Causation Factors for the Banjar Panji No. 1 Blowout

***Neal Adams Services
September 15, 2006
Jakarta, Indonesia***

RE: Report as Per Consulting Services Agreement
Causation Factors for the Banjar Panji No. 1 Blowout

Figure 7.4 Bottom Liner Based on Pore Pressure and Fracture Pressure

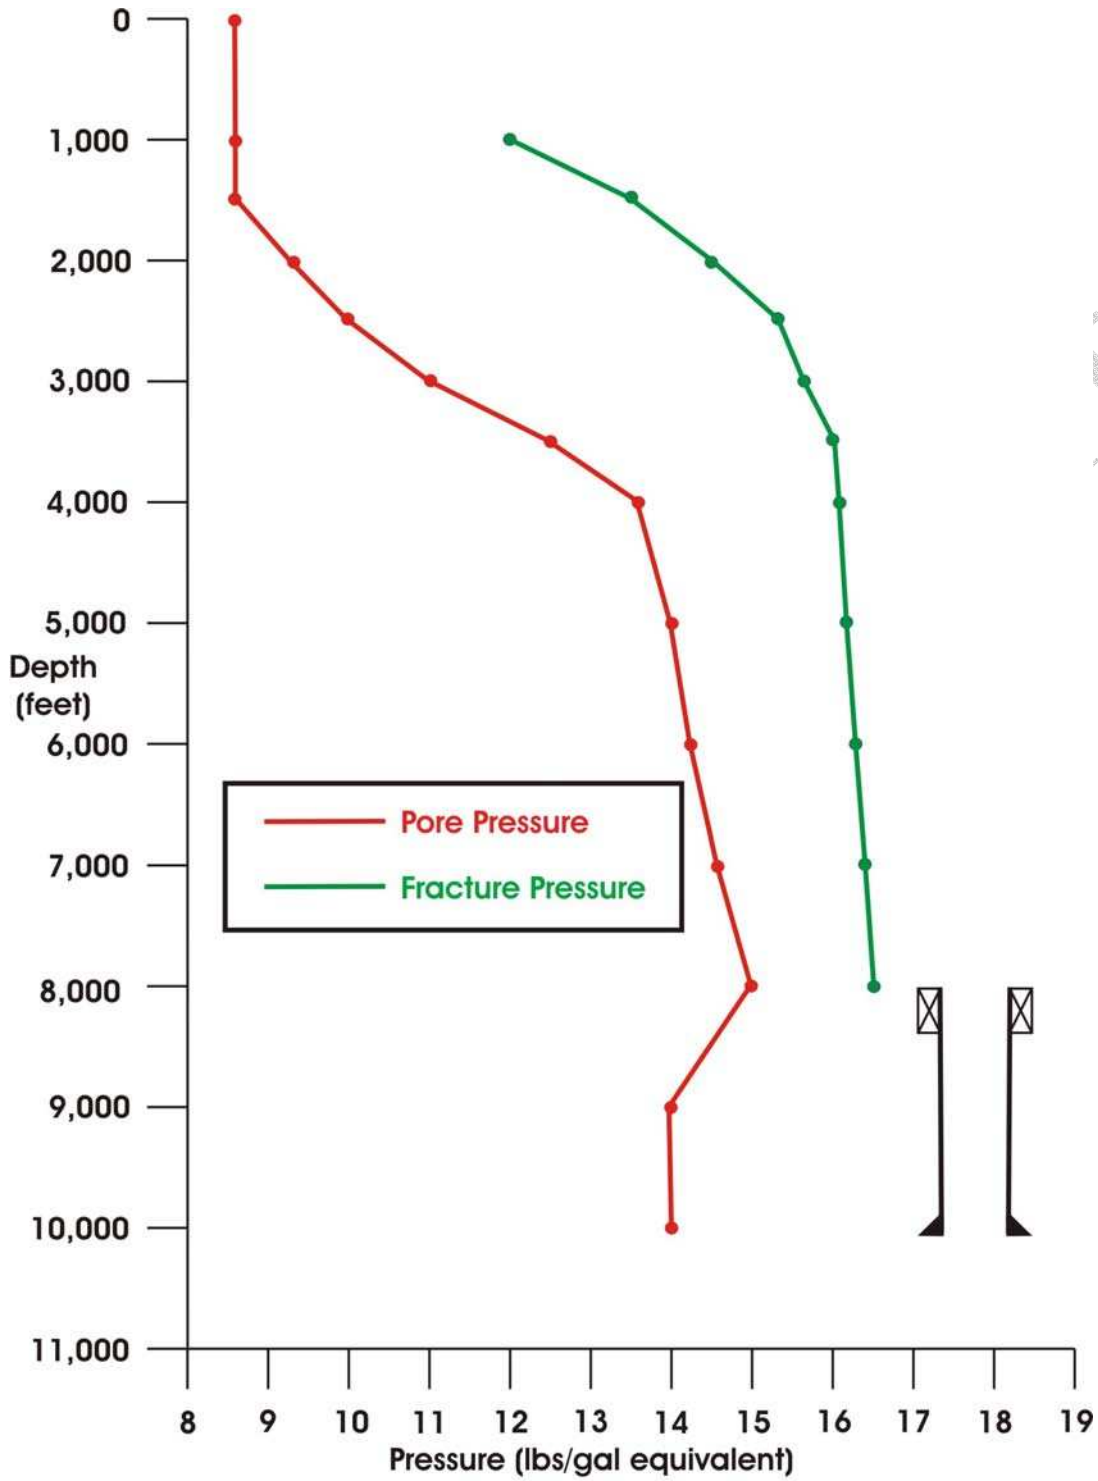
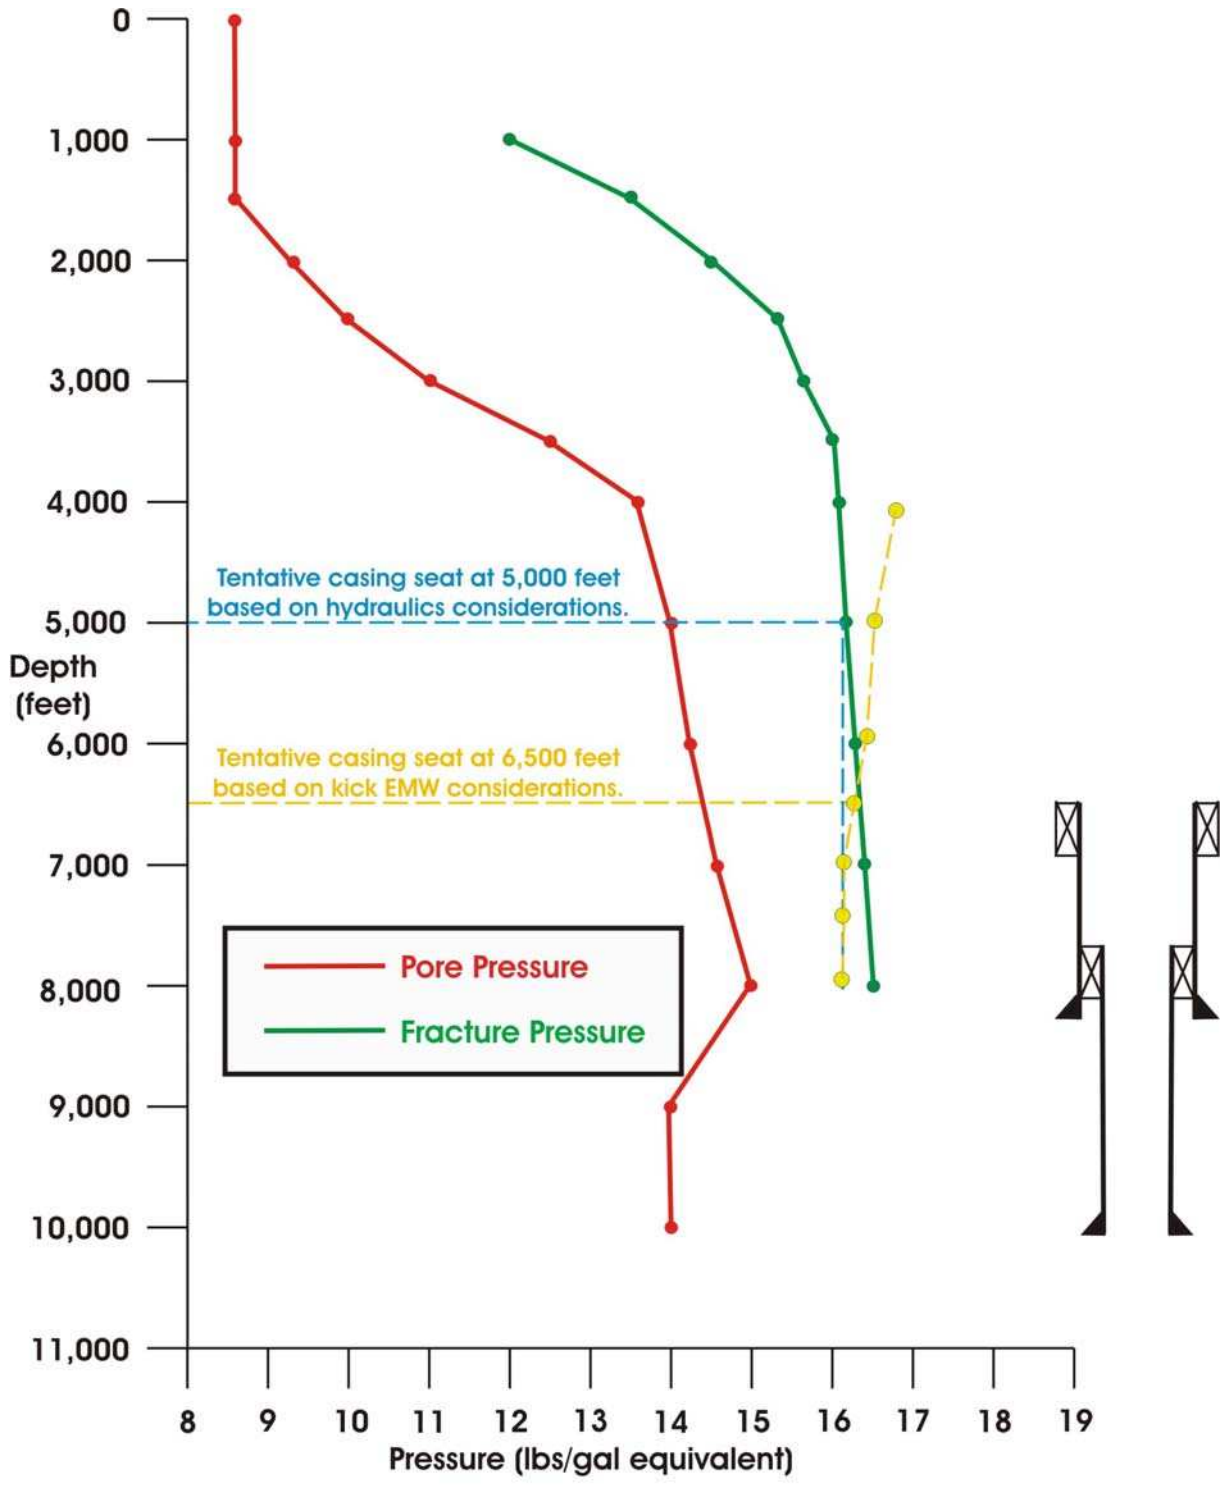
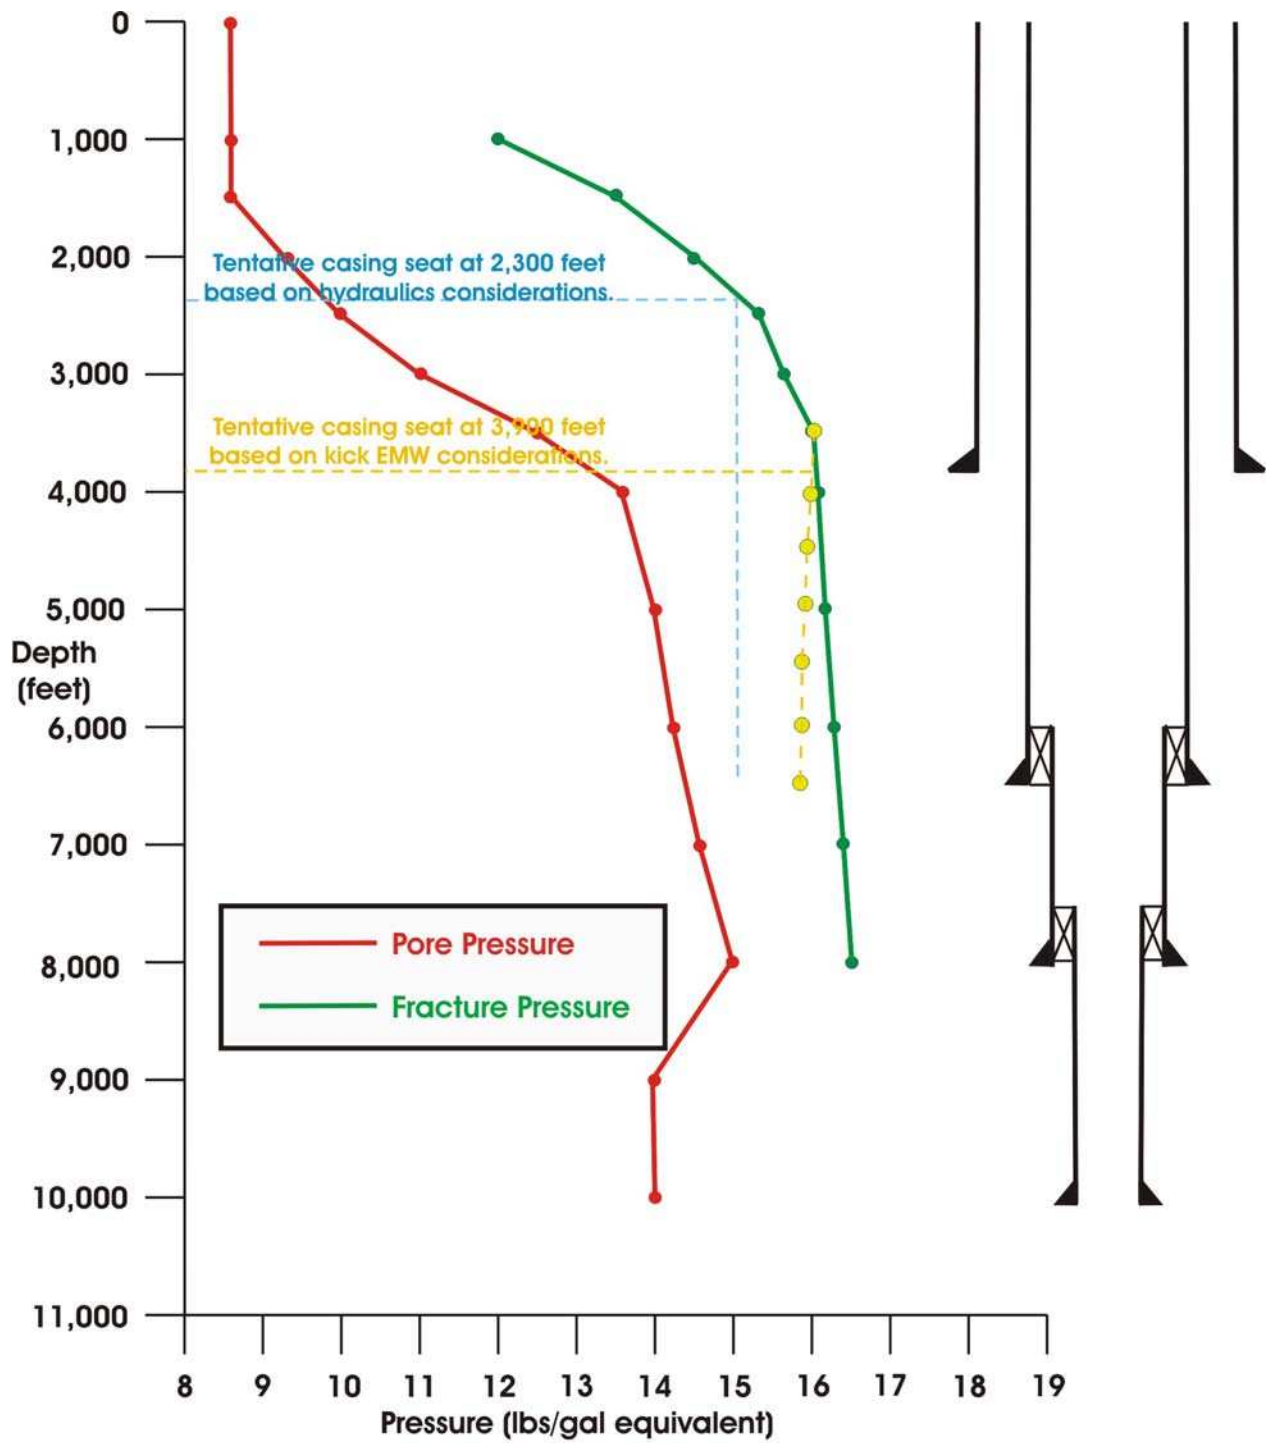
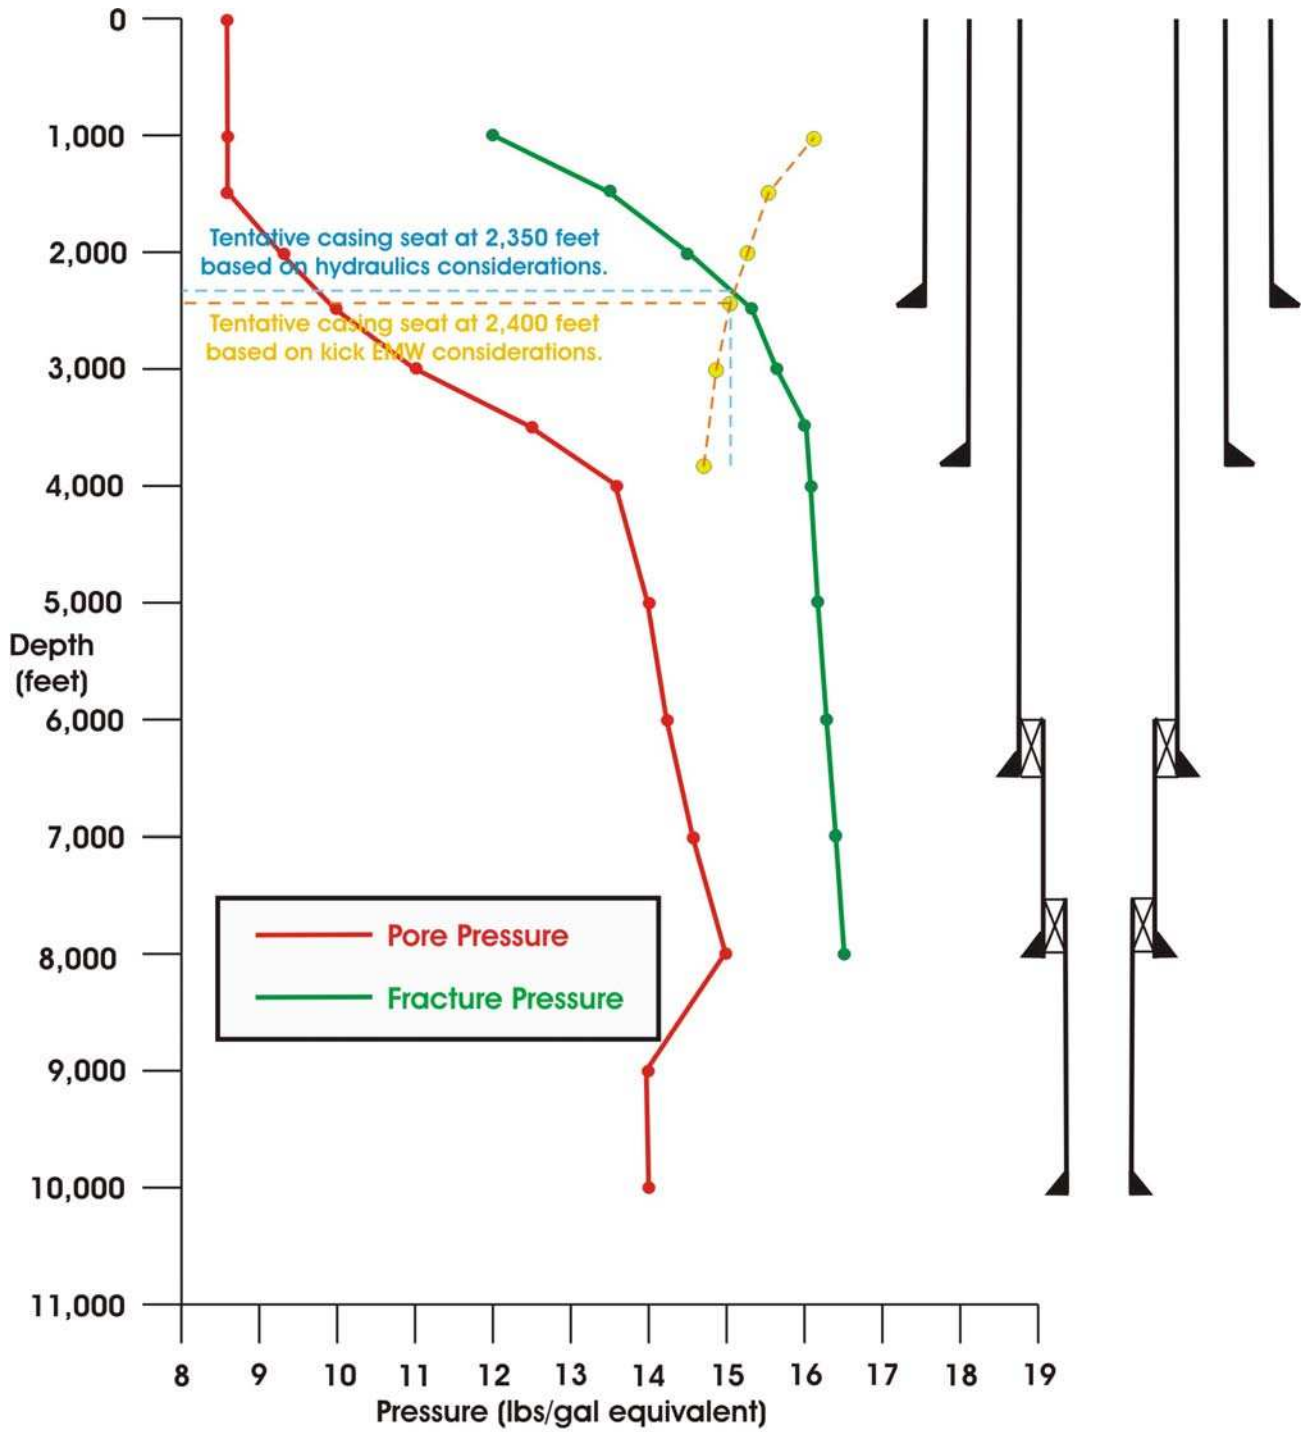
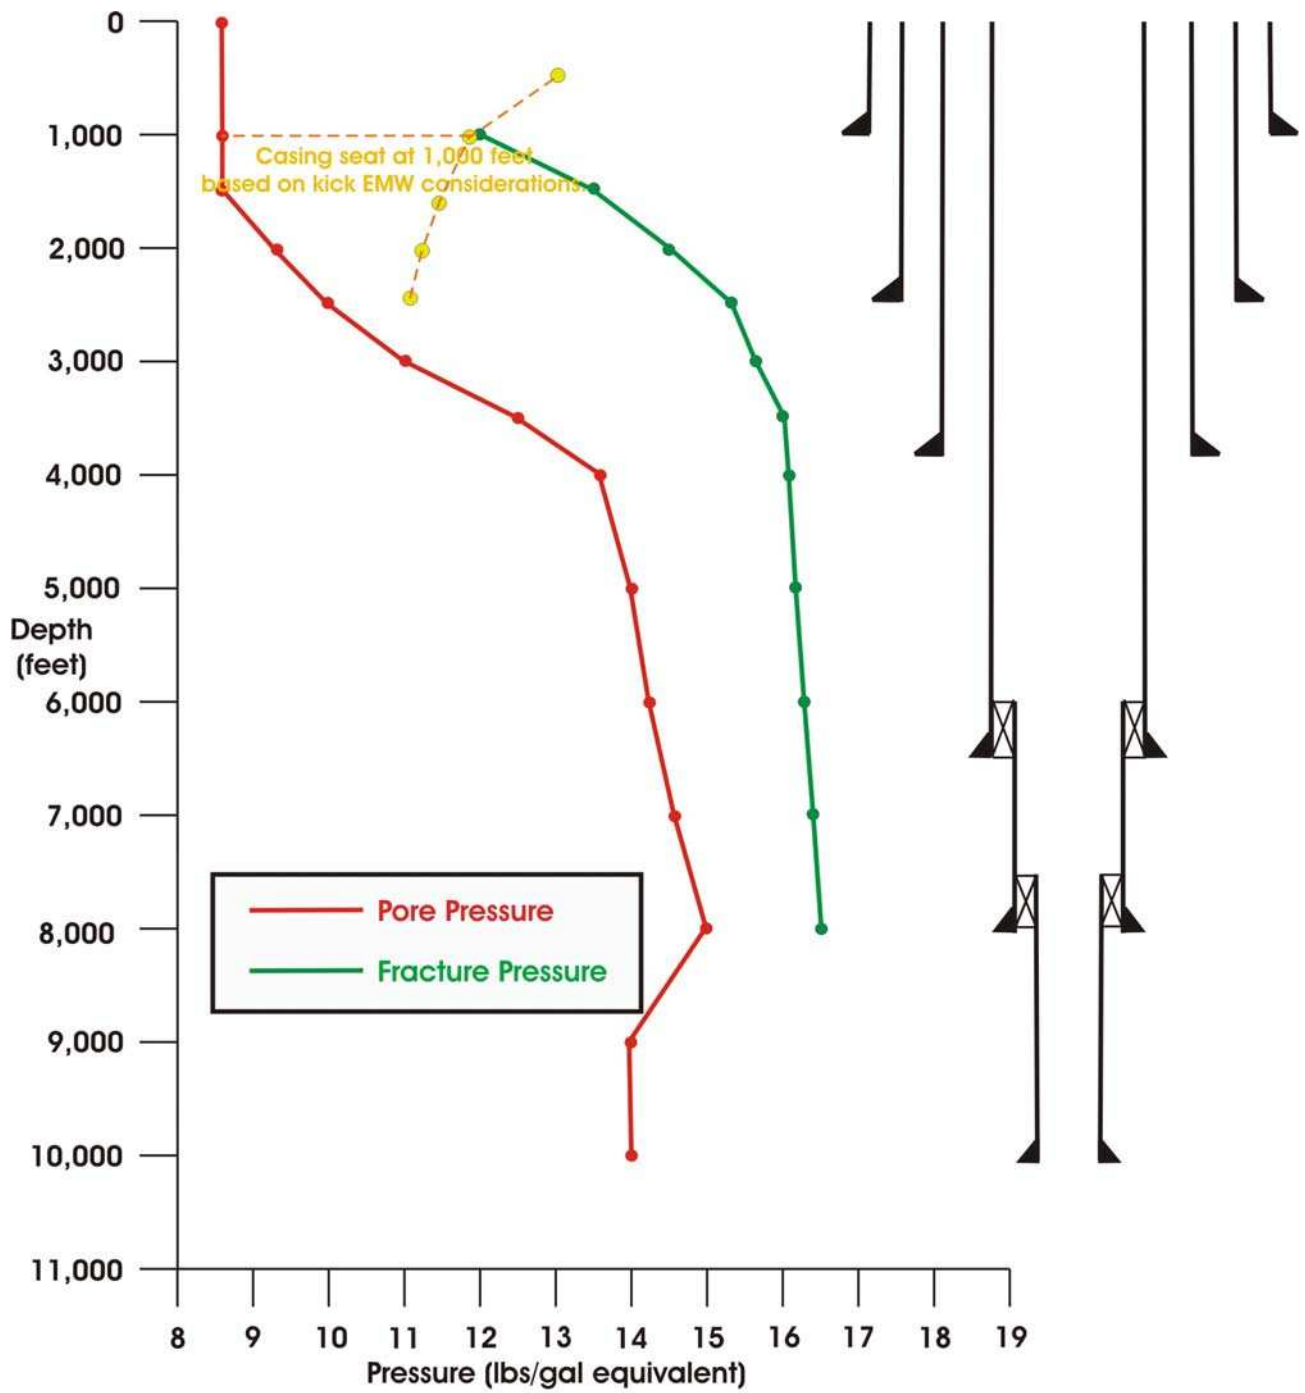
This technique by Adams has been applied for the formation pressure and fracture pressure data shown in Figure 7.3. The results are shown in Figure 7.4 to Figure 7.8. Casing and/or liner depths are shown. Pipe and hole sizes, not shown here, would be developed on several other variables.

Figure 8.1 Analysis of LOT Data for the 13-3/8 inch Casing.

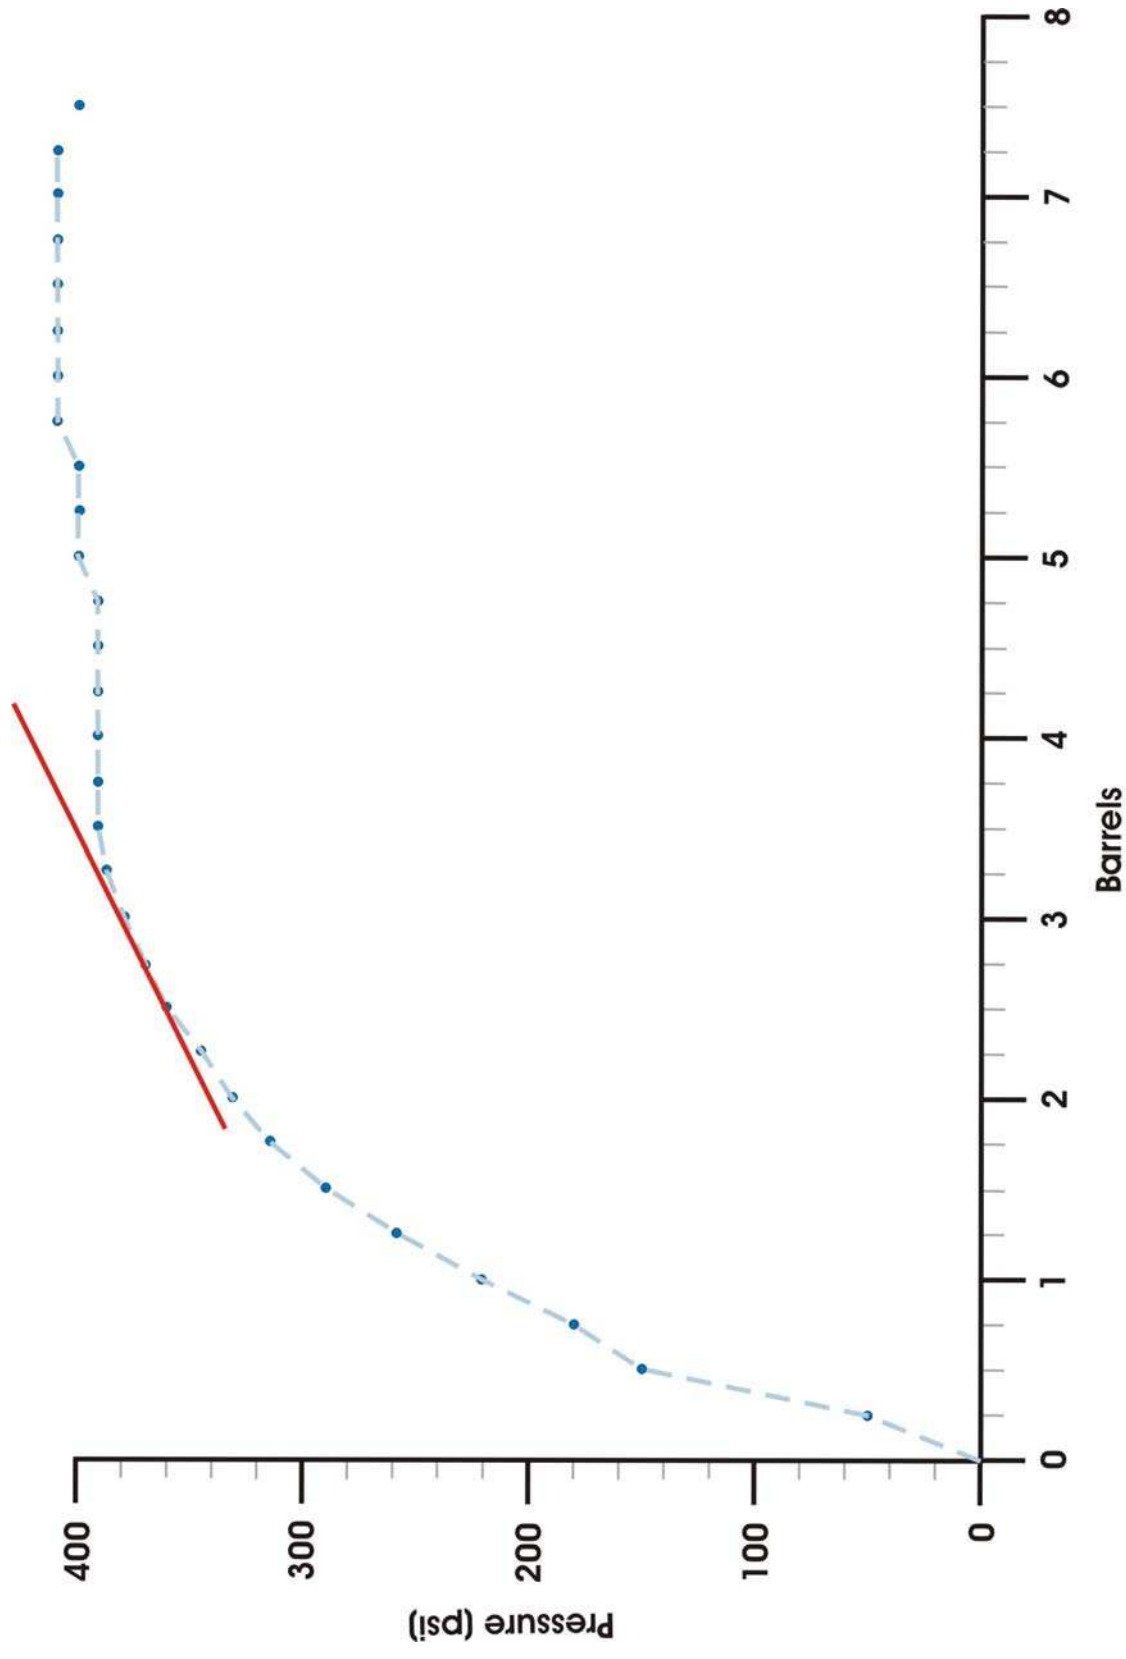
Leak off tests were performed on each casing string after the float shoe was drilled. The LOT pressure results shown in the DDRs show the gauges used to capture the pressures resulting in reading variations. As an example, the LOT data for the 16 inch liner had pressure readings from three gauges, all which were different. The LOT program relies on accurate gauge readings, which may not have been in play in this case. Specific data points for plotting the LOT results were available only for the 16 inch liner.

Also, LOT interpretation on the 16 inch liner, which was the only casing LOT where the data were available, shows a questionable practice when gathering the data. The LOT should be stopped when the initial leak off is observed. This occurred after approximately three barrels of mud were pumped. However, the Operator continued injection to eight barrels, which would have caused the testing fracture to be extended beyond the length required to achieve a good test. A LOT similar analyses could not be performed on the shallower casing strings as a complete data set was not available.
